# UNITED STATES PATENT AND TRADEMARK OFFICE

<b>Office Action Summary</b>	<b>Application No.</b> 10/587,451	<b>Applicant(s)</b> AMANO, RYUICHIRO	
	<b>Examiner</b> NATHAN ZOLLINGER	<b>Art Unit</b> 3746

**Detailed Action**

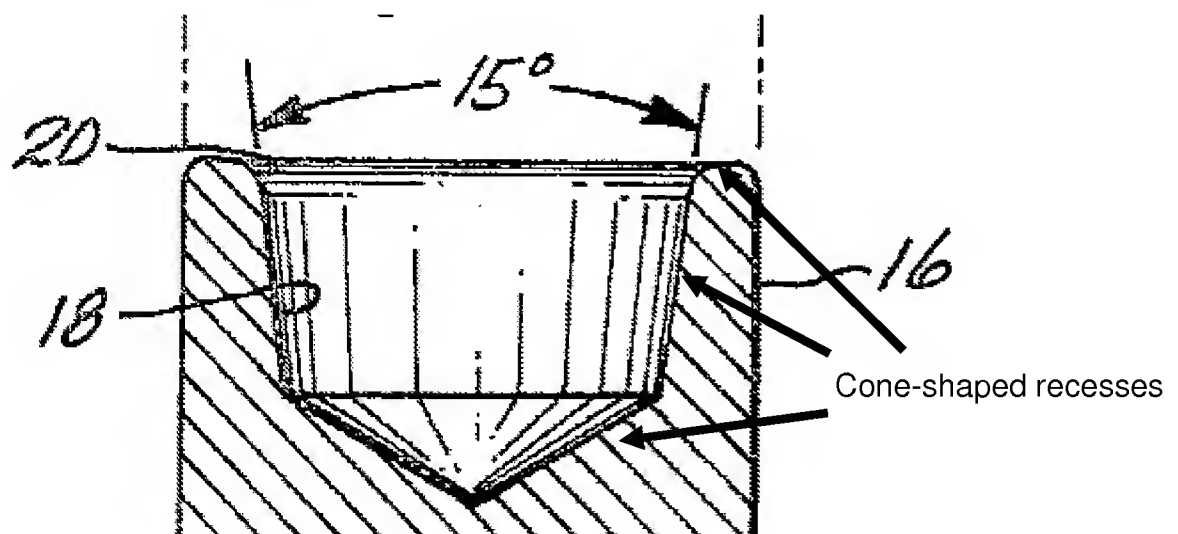
**Claim 5:** Hufnagl discloses a method of plate installation comprising mounting a plate member (24) on a supporting base plate (12 OR 12 & 26) by fitting a projection (16) of the supporting base plate into a through hole (28) of the plate member to project a top end part of the projection from the through hole, the supporting base plate having a projection with a cone-shaped recess (Examiner notes several candidates depicted

below which are on an “upper face” of the projection) on an upper face of the projection; and crushing (Fig. 4) a projected part of the projection from the through hole except for a portion of the cone-shaped recess on the projection by applying a downward pressing force to the projected part so as to integrate the plate member with the supporting base plate such that a bottom portion of the cone-shaped recess exists in a state of the projection being crushed (Fig. 4). Hufnagl also discloses a cone-shaped recess having an opening diameter of about 50% of an outer diameter of the projection and a depth of 10 to 15 % of the outer diameter of the projection (Examiner chooses the bottommost recess which is about 50% of the OD and which has a depth of around 15% the OD).

**FIGURE 3**

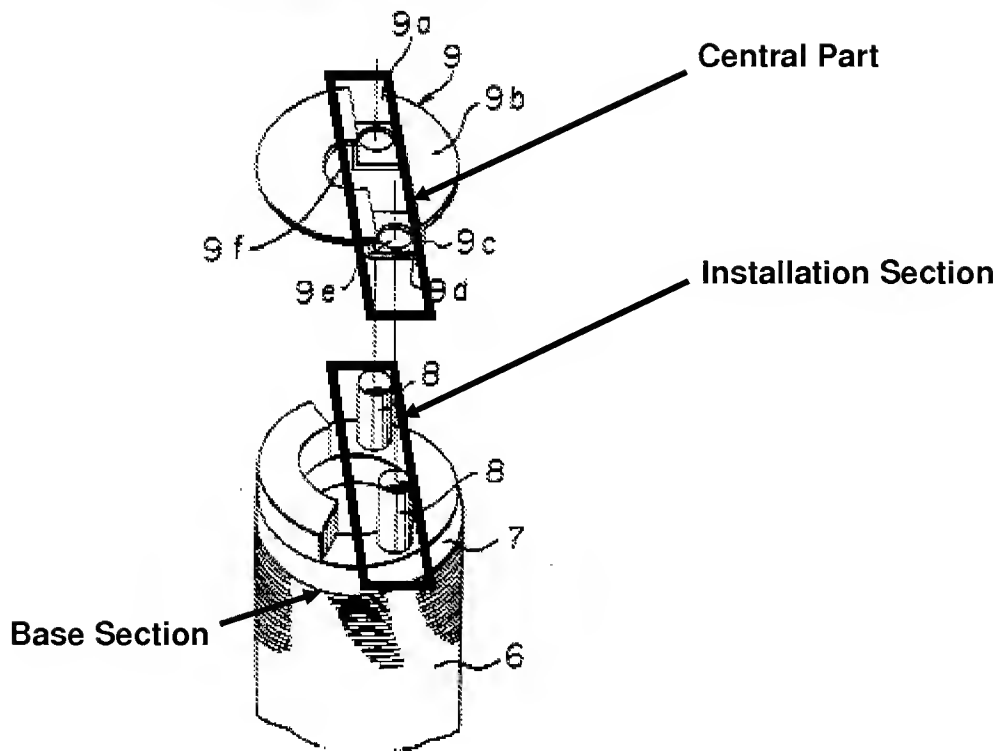
Muramatsu also does not disclose a projection with a cone-shaped recess with a diameter that gradually decreases downward on an upper face of the projection. Hufnagl teaches connection device in which a rivet projection possesses a cone-shaped recess that gradually decreases downward on an upper face of a projection (Examiner notes several candidates depicted above). It would have been obvious at the time the invention was made to a person having ordinary skill in the art to employ a cone-shaped recess as taught by Hufnagl in order to limit the outward pressure of the projection upon the clamped body (in the case of Muramatsu, it would be the separation plate; see col. 1, lines 55-58). Hufnagl also discloses a cone-shaped recess having an opening diameter of about 50% of an outer diameter of the projection and a depth of 10 to 15 % of the outer diameter of the projection (Examiner chooses the bottommost recess which is about 50% of the OD and which has a depth of around 15% the OD).
